Access Compliance Report

Public Rights-of-Way

Intersection ID: 7610	Main Street: NICOLET_GLEN_DR	Cross Street: TWEEDSMUIR_GLEN_LN	Location: SE
ADA ID: EDB7339B987B	Ramp Type: Directional	Initial Pass/Fail: Pass	Overall Compliance: No
Codes/Mitigation Info/Possible Solution			Severity Score: 15
			Field Measurements/Component Compliance

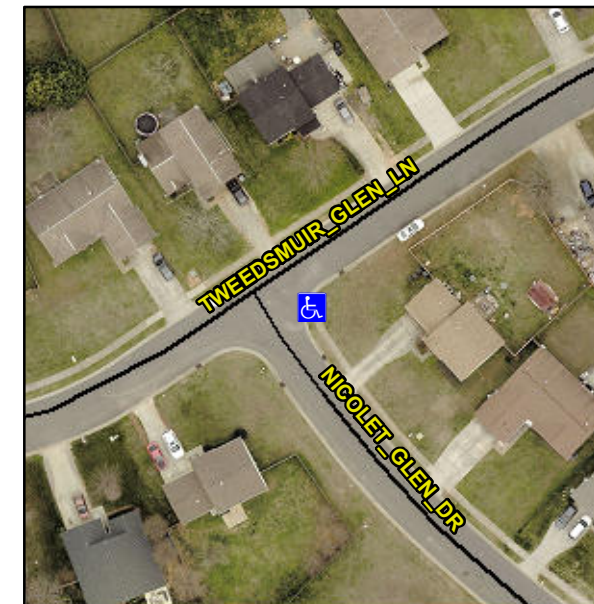
CRACK LT FL

**R304.2.1, R304.2.2-Perp, R304.3.2-
Para, R304.5.3, R305, R304.5.4**

**Remove & Replace Entire Ramp.
Remove & Replace Gutter.**
